**ADDENDUM #2**  
INVITATION FOR BID #24-65

**NEWTON COMMONWEALTH GOLF COURSE MAINTENANCE FACILITY  
IMPROVEMENTS AND RENOVATIONS**

Addendum to the Bidding Documents  
**Newton Commonwealth Golf Course**  
**Maintenance Facility Improvements & Renovations**

Addendum No. 2  
April 22, 2024

1 HVAC UPPER FLOOR PLAN  
SCALE: 1/8" 1'-0"

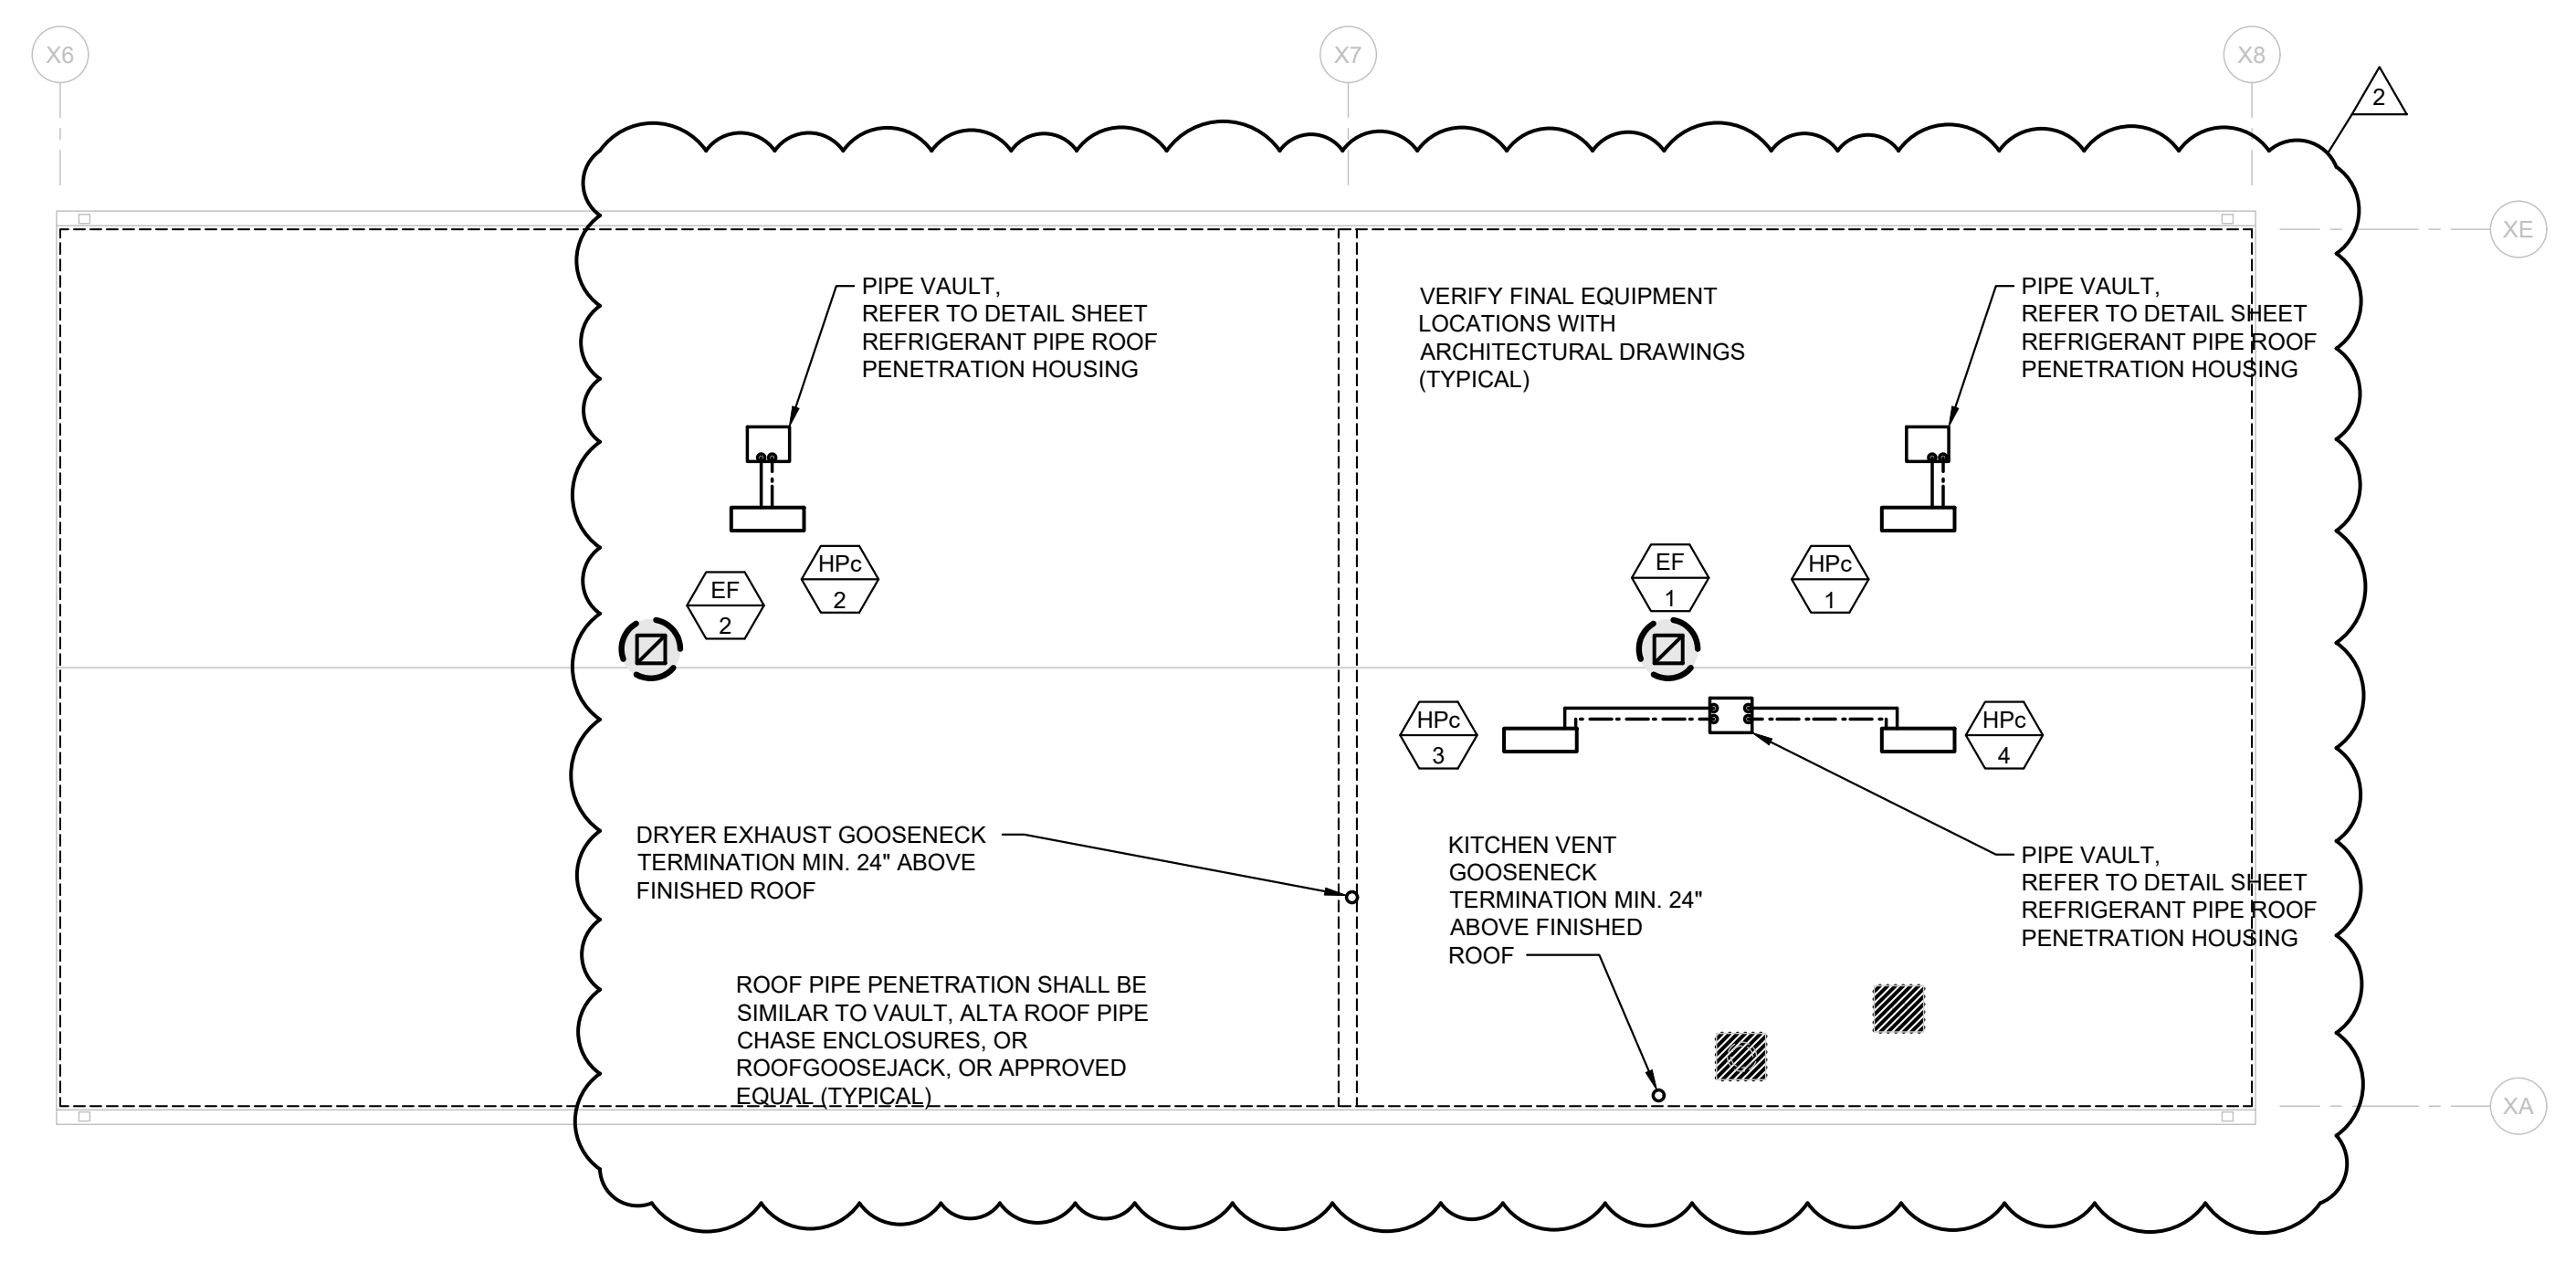
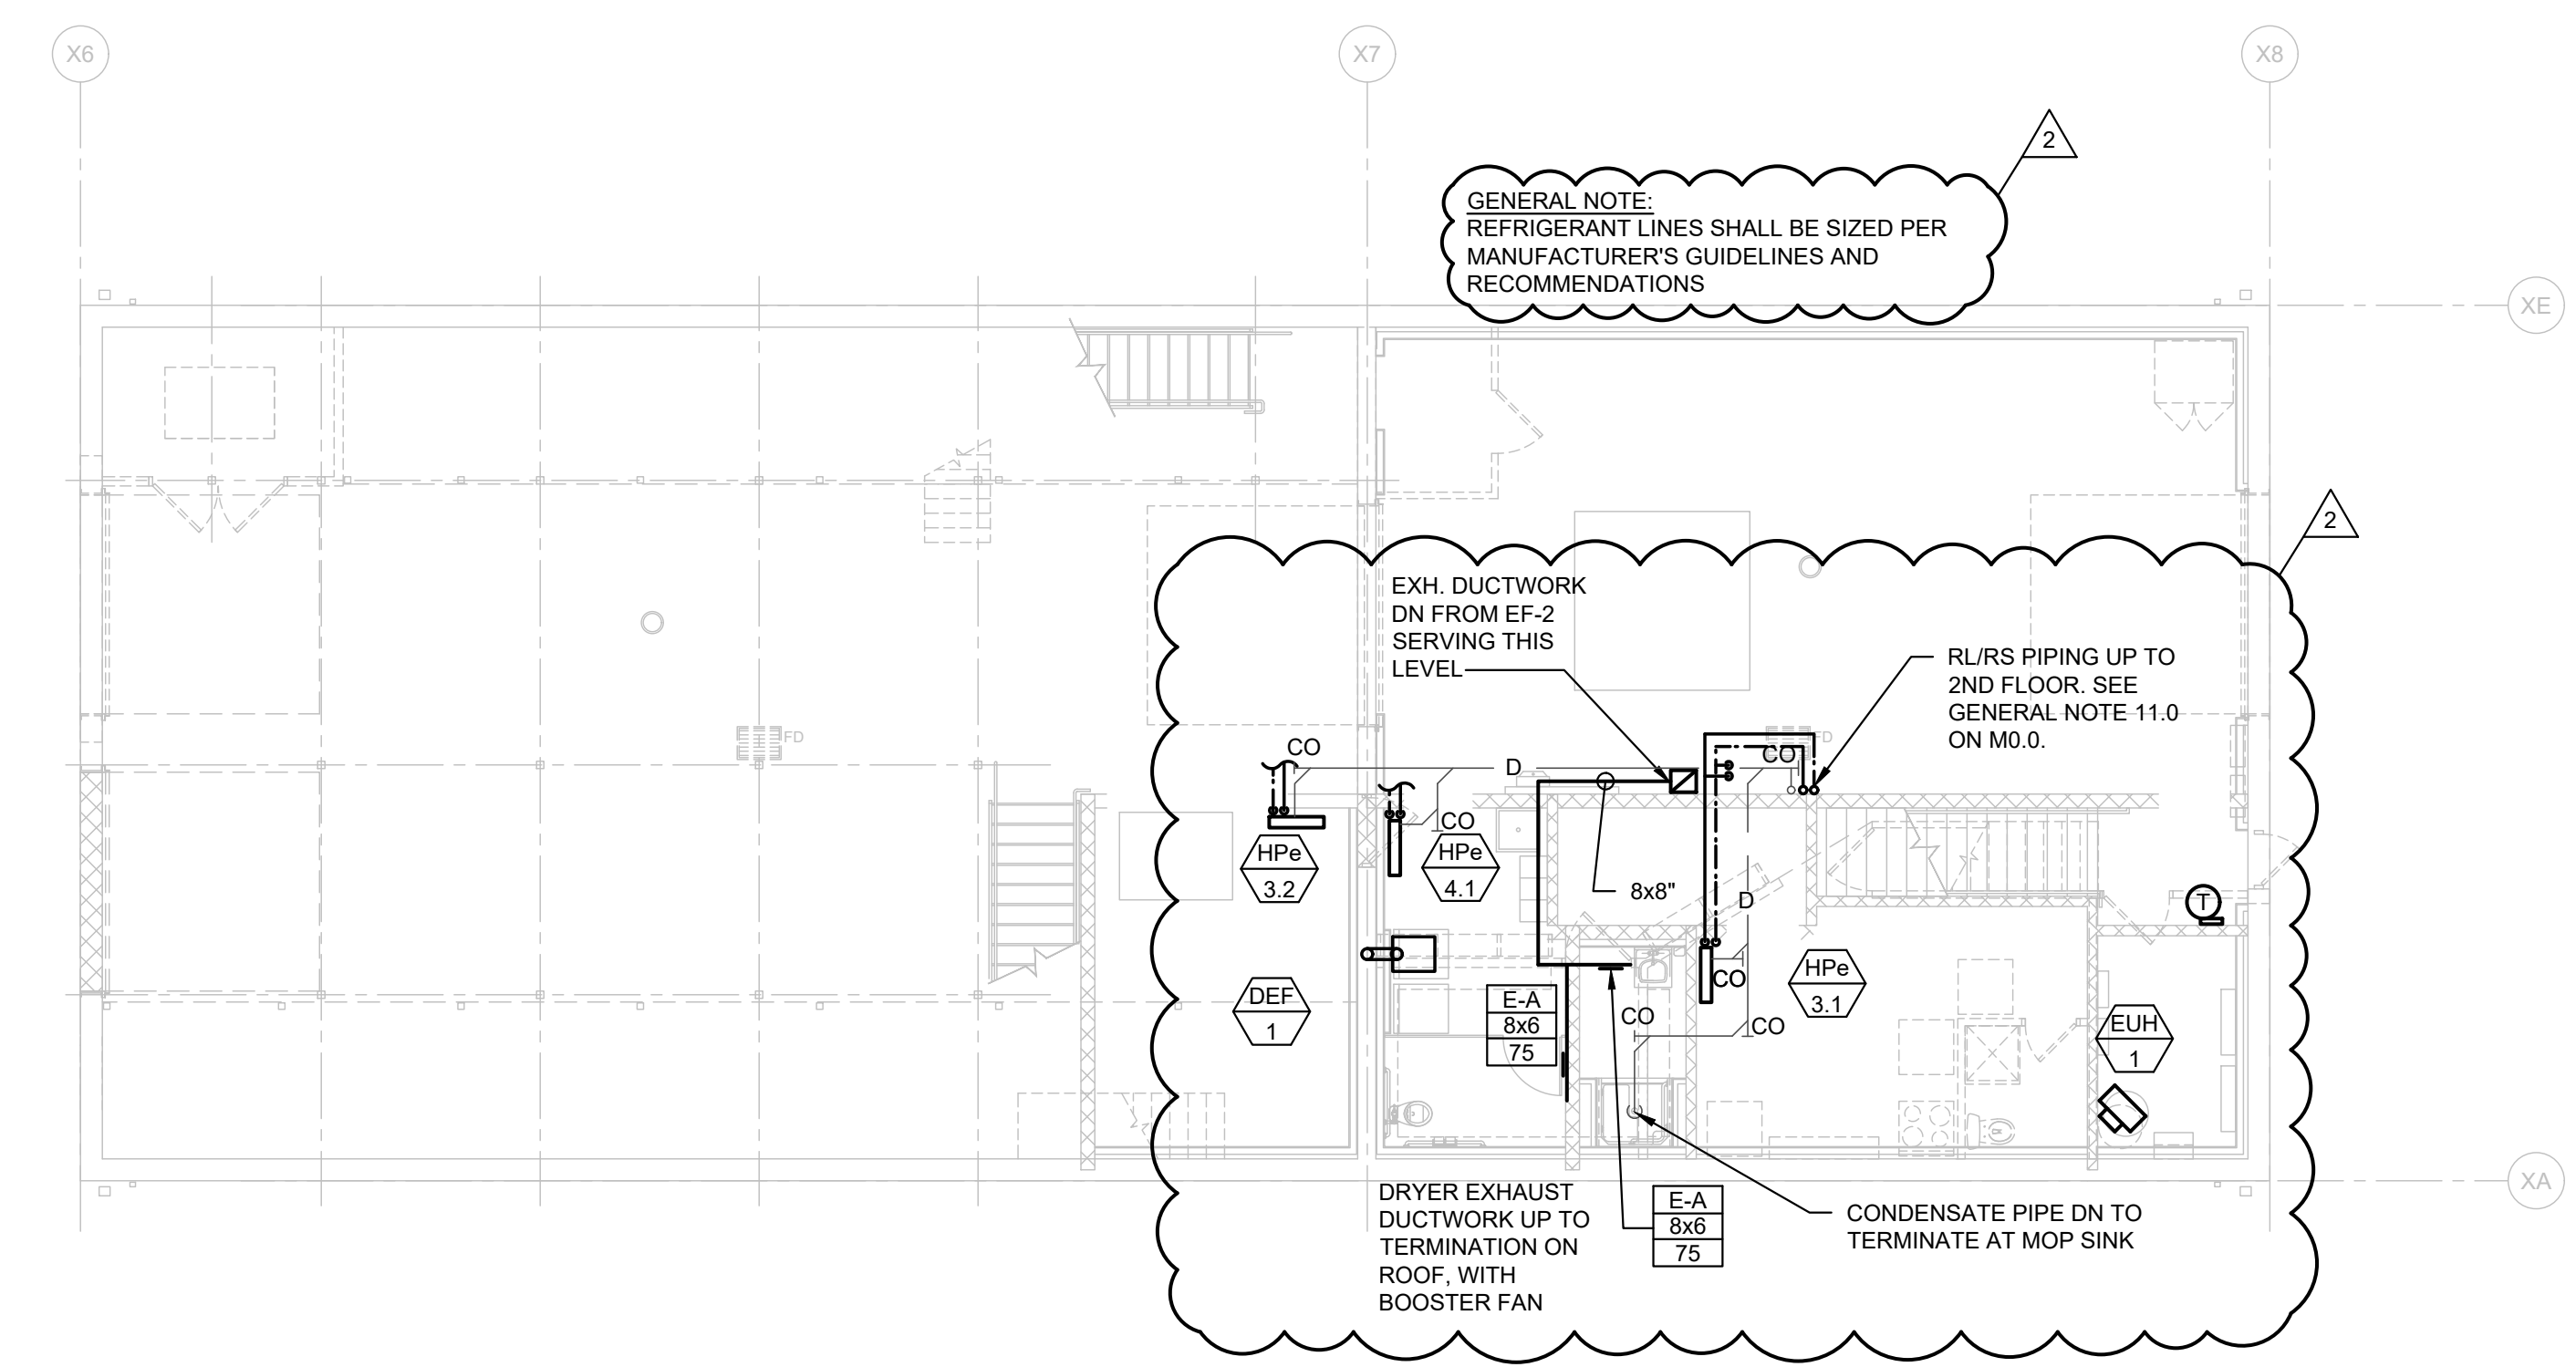
**Q3. HPc-4 is scheduled to have associated indoor units HPe-4.1,4.2,4.3,4.4 however the plan view on M1.0 does not show the piping feeding those associated Indoor Units. Please revise this plan to show the correct piping layout.**

**Q4. HPc-3 is scheduled to have associated indoor units HPe-3.1,3.2 however the plan view on M1.0 does not show the piping feeding those associated Indoor Units. Please revise this plan to show the correct piping layout.**

**Q9. Please show on Plan M1.0 all condensate pipe as none is currently shown.**

**A3. M1.0 PIPING LAYOUT FROM CONDENSING UNITS TO INDOOR UNITS DOES SHOW PIPING TO EACH UNIT.**

**A4. M1.0 PIPING LAYOUT FROM CONDENSING UNITS TO INDOOR UNITS DOES SHOW PIPING TO EACH UNIT.**

**A9. REFER TO M1.0 FOR CONDENSATE PIPE**

**DESTRATIFICATION FANS**  
(NOT TO SCALE)

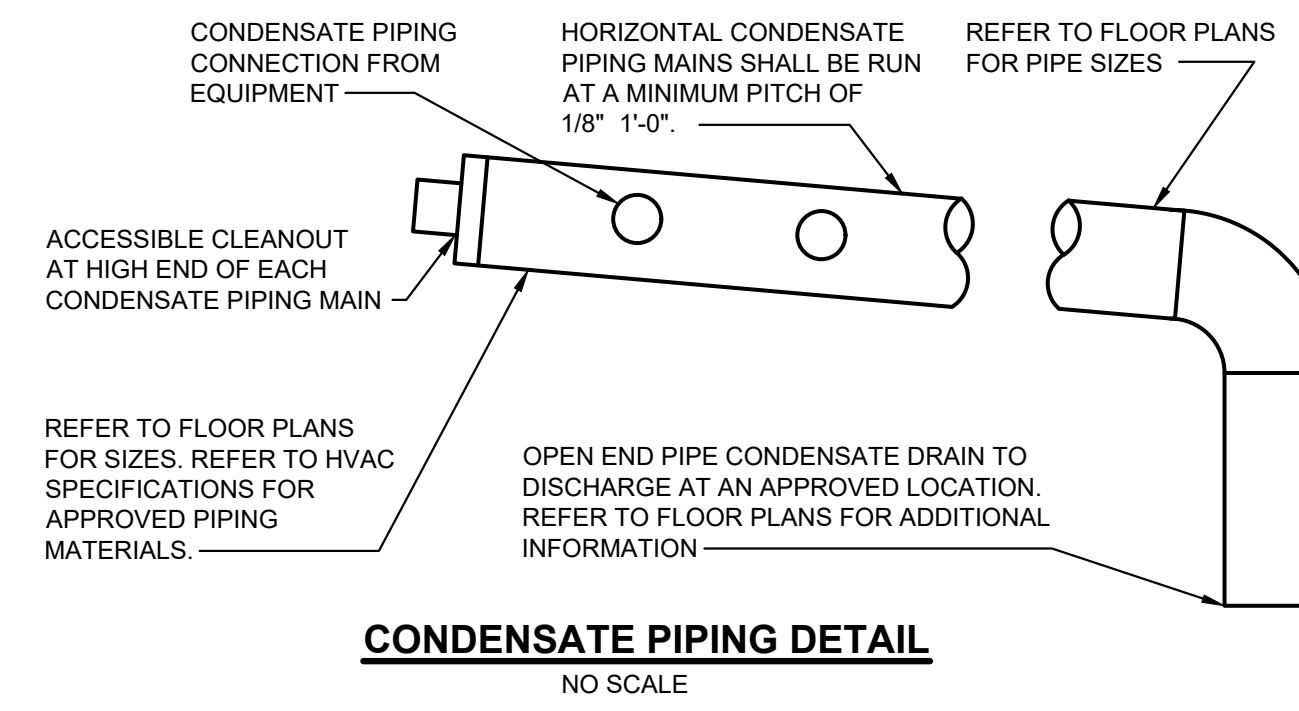
**Q14. Schedule on M0.0 for the destratification fans calls for ZOO Fans IC-Series. These fans are designed primarily for drop ceilings and can also be installed in hard lids. "IC" stands for "In-Ceiling". The floor plans show these drawn like Big Ass Fans and Big Ass Fans are listed in the spec. The scheduled "IC Silent AC Fans" do not look like the fans shown on the floor plans or the Fan Detail on M4.0.**

**A14. REFER TO UPDATED DESTRATIFICATION FAN SCHEDULE ON M0.0**

### DUCTLESS COOLING UNITS (DCU)

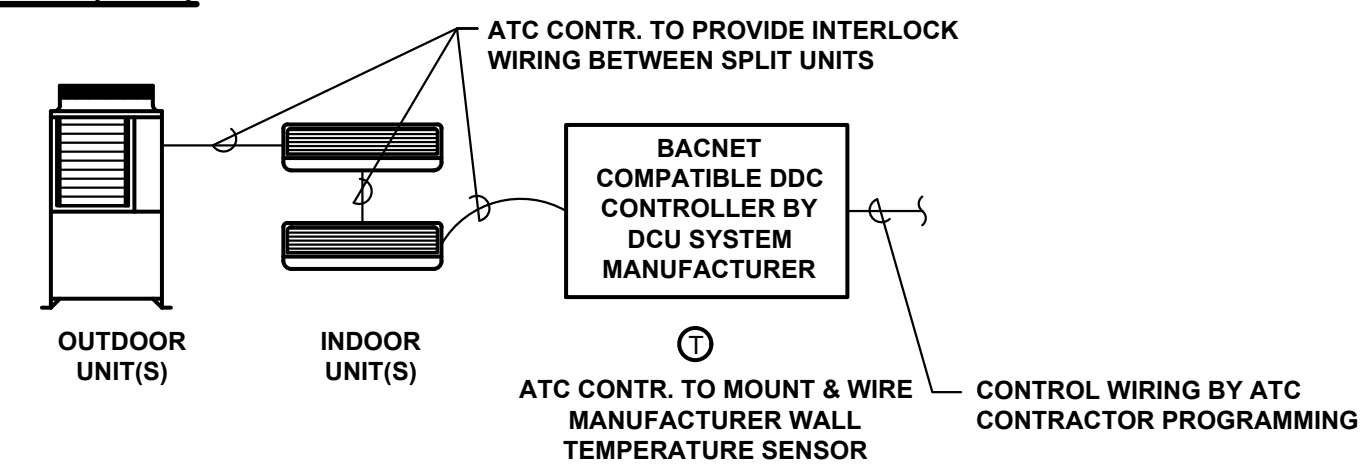
**Q13. Plan M4.0 Ductless Cooling Units detail states "overflow sensors are to be interlocked with the Building Management System". Is there an existing DDC System and ATC Contractor currently in the space? Or confirm that the control system for the new HVAC equipment is standalone**

**A13. NO BUILDING MANAGEMENT SYSTEM. OVERFLOW SHALL SEND THE UNIT INTO ALARM AT THE HEAT PUMP FRONT END CONTROL PANEL.**
